***RESPONSE TO NRC STAFF
ASSESSMENT (SECY-11-0137) of
NTTF RECOMMENDATIONS***

Prepared Comments of Christopher E. Paine
Nuclear Program Director, Natural Resources Defense Council (NRDC) on
SECY-11-0137, "Staff Assessment and Prioritization of Near-Term Task Force Recommendations."
October 11, 2011

***Briefing on the Japan Near
Term Task Force Report –
Prioritization of
Recommendations***

***UCS Perspective on the
Prioritization of NTTF
Recommendations***

Figure 5: In-Vessel Severe Core Damage calculations using historical weather data for the month of October: four separate HPAC model runs showing the different plumes resulting from an accident at Indian Point Unit 3 occurring at different times of the day.

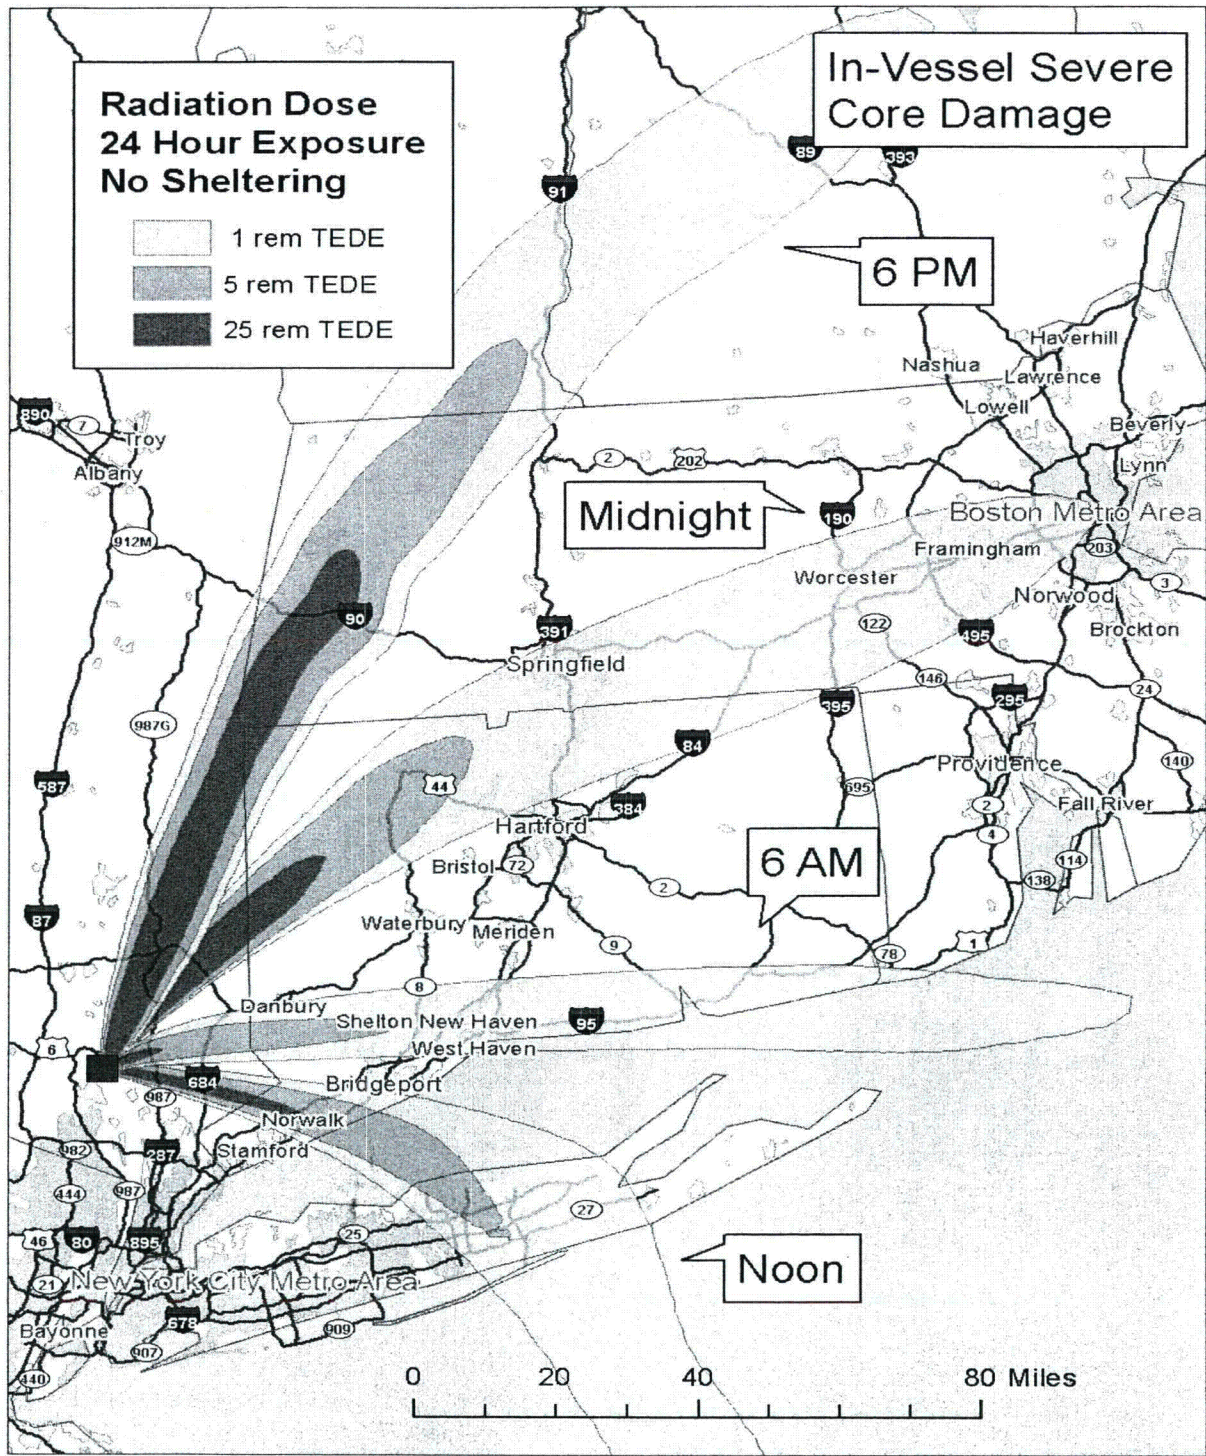
- At what point, if ever, does the population and economic significance of an area at risk from a severe nuclear accident impose limits on the practical, financial, or moral efficacy of engaging in emergency preparedness planning.
- If there are such common sense limits, how should they find regulatory expression:
 - –in an operating license condition for existing reactors that would compel closure when the population at risk exceeds a certain level within the maximum credible radius for a severe accident (e.g. the 17 million within 50 miles of Indian Point)?
